WRITTEN REPRESENTATION FOR DEADLINE 1 – 20 MAY 2025

PLANNING INSPECTORATE REFERENCE NUMBER: EN020028

MADE ON BEHALF OF D LUND AND M FARE FARMING PARTNERSHIP

The relevant document of reference is MORGAN AND MORECAMBE OFFSHORE WIND FARMS: TRANSMISSION ASSETS Environmental Statement Volume 1, Annex 4.3: Selection and Refinement of the Onshore Infrastructure

Drawing Title:
Works Plan - Sheet 14 of 21
AFPF Regulation: 5(2)(k)
Document Reference: B7

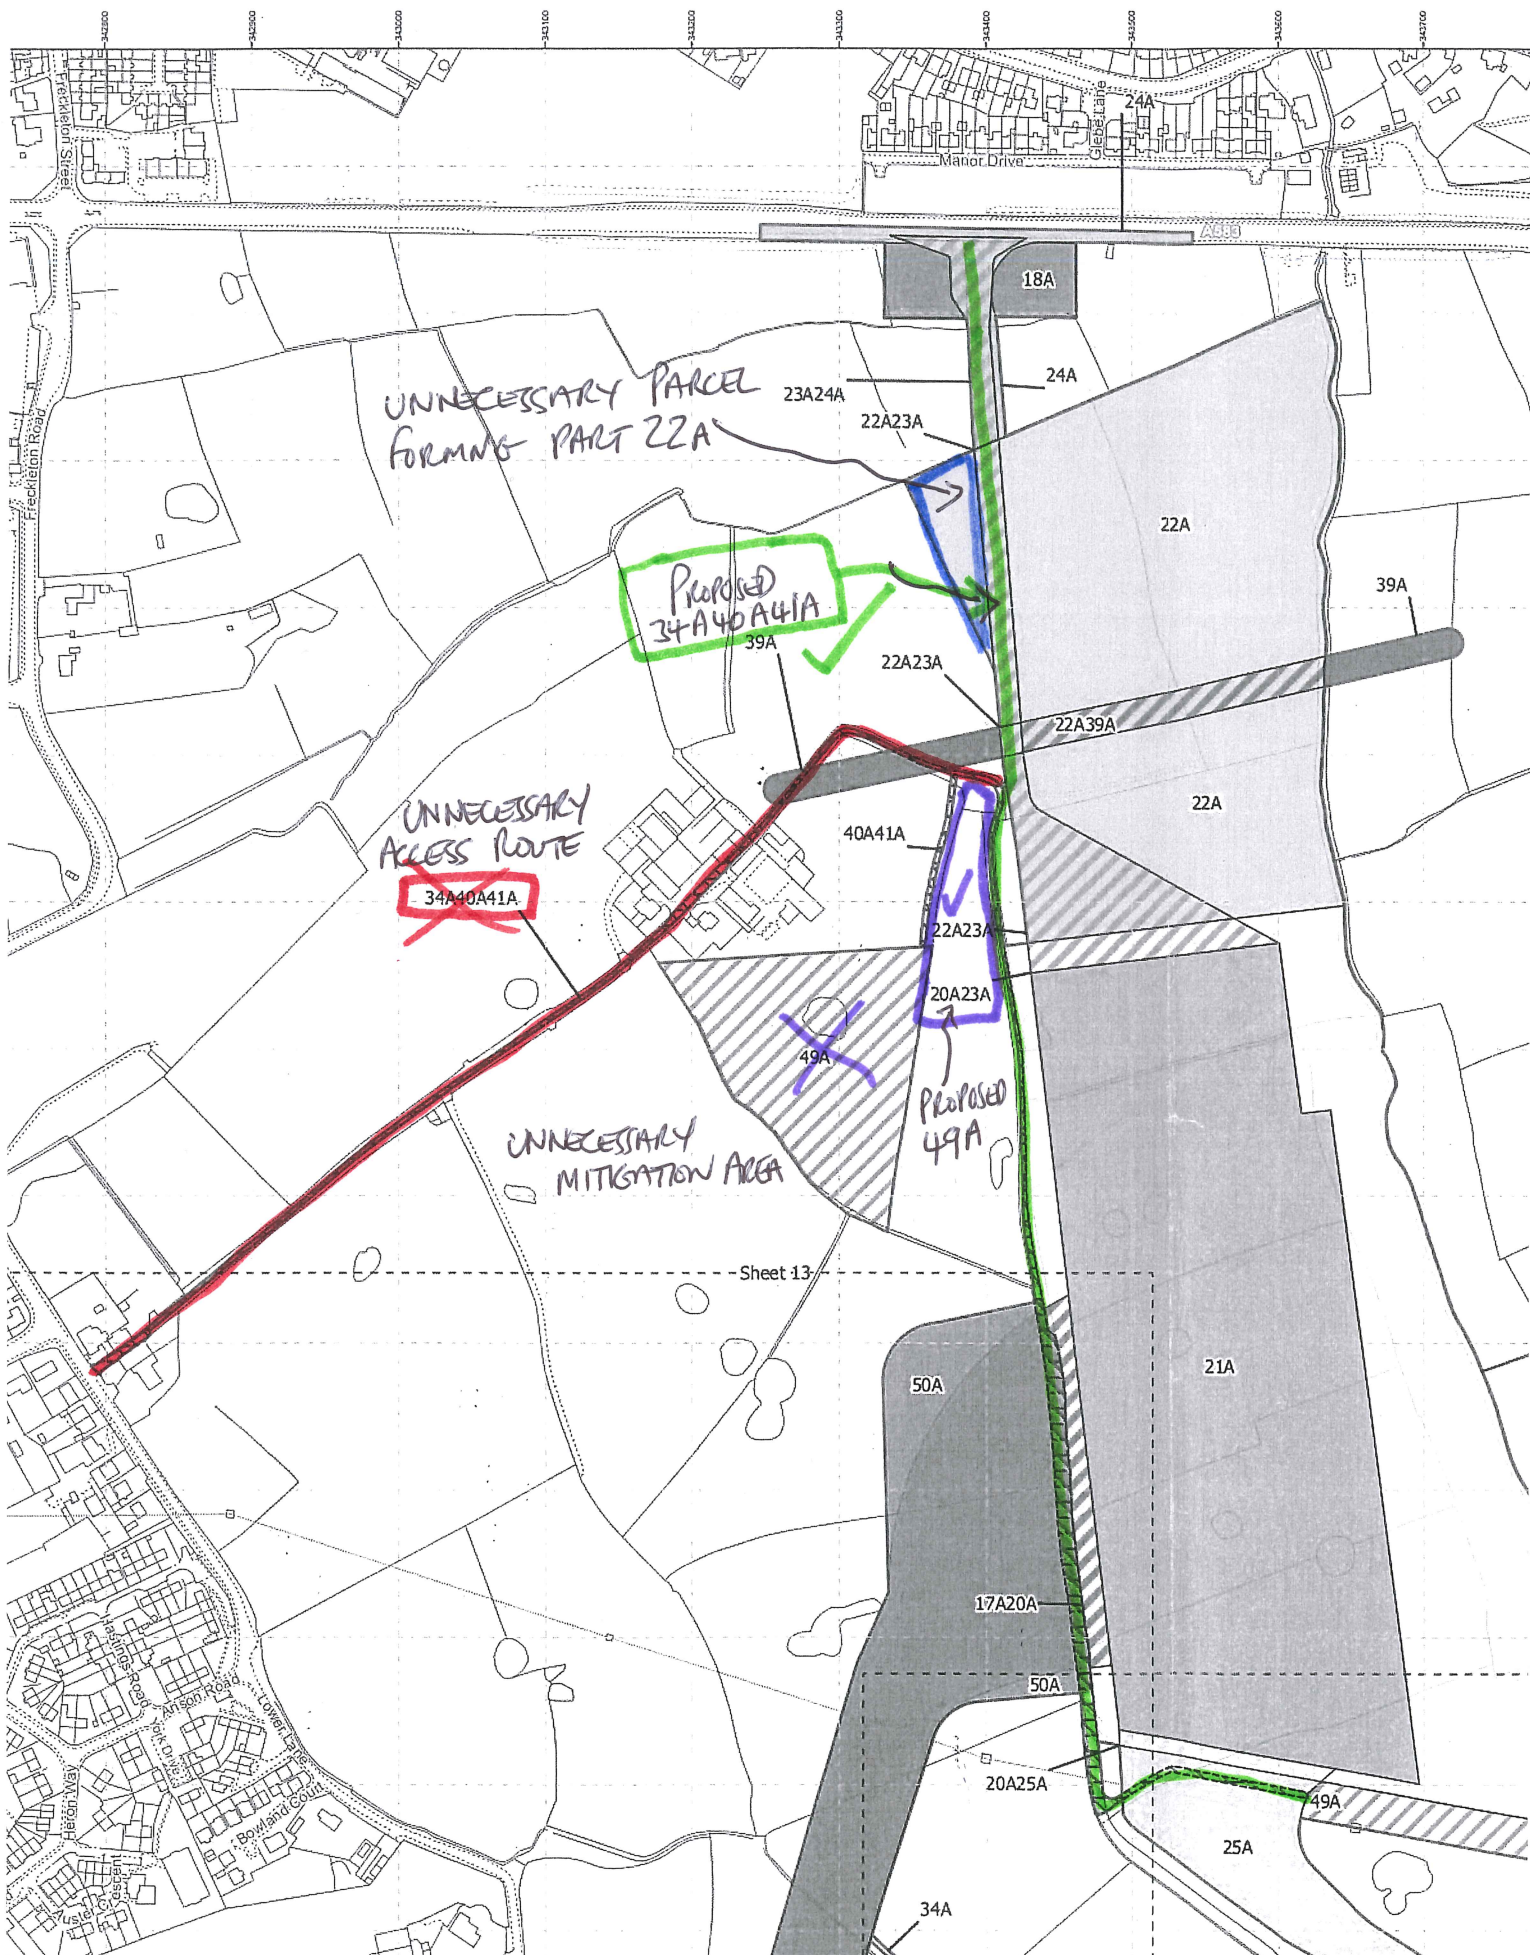
Temporary Works - SI Works 22A which is proposed to be located on the west side of the proposed permanent haul road and whilst this is temporary area we consider this unnecessary for the construction of either the haul road or the substation. shown edged in blue on the attached identification plan.

The Projects propose permanent access rights to access biodiversity mitigation areas over the private farm access road serving Greenbank Farm and Freshfield Farm identified as SI Works 34A40A41A. This proposed permanent access is wholly unnecessary as the Morgan Project will have permanent access from the A583. SI Works 34A40A41A impacts residential amenity and business security as the proposed vehicular access passes through residential properties off Lower Lane two residential farm properties and private farm yards.

This proposed permanent access is wholly unnecessary, shown coloured in red on the attached identification plan. We have proposed a much more suitable access shown coloured in green on the attached identification plan.

This biodiversity mitigation access route is to proposed mitigation area SI Works 49A which is in a wholly inappropriate location abutting Freshfield Farmhouse and causes loss of amenity countryside views to the south from Greenbank Farmhouse. There is no description of what this area is mitigating and there has been no prior discussion with the landowner at Greenbank Farm or Freshfield Farm for this proposed siting. It would appear that SI Works 49A is a biodiversity enhancement which is not a requirement for Project A as BNG is not a legal requirement. If the Projects had liaised with the landowner then there would have been a likelihood of jointly agreeing suitable location(s) for permanent environment mitigation works however this was not discussed/considered by the Projects until it was too late to amend the submitted plans. Proposed SI Works 49A should be relocated to an approximate location shown edged in purple on the attached identification plan which includes an existing pond/pit not previously identified on surveys.

There is a small triangular section of temporary works SI Works 22A which is proposed to be located on the west side of the proposed permanent haul road and whilst this is temporary area we consider this unnecessary for the construction of either the haul road or the substation. Project A has verbally agreed that this triangle area appears unnecessary however the Project would not remove this temporary area simply due to the fact that the planning application had been submitted. We request that this temporary area is removed from the planning application as unnecessary particularly given the large temporary compound to the east of the proposed permanent haul road. There is no need to disturb any additional land on the west side of the haul road as we consider this unnecessary for the construction of either the haul road or the substation. shown edged in blue on the attached identification plan.
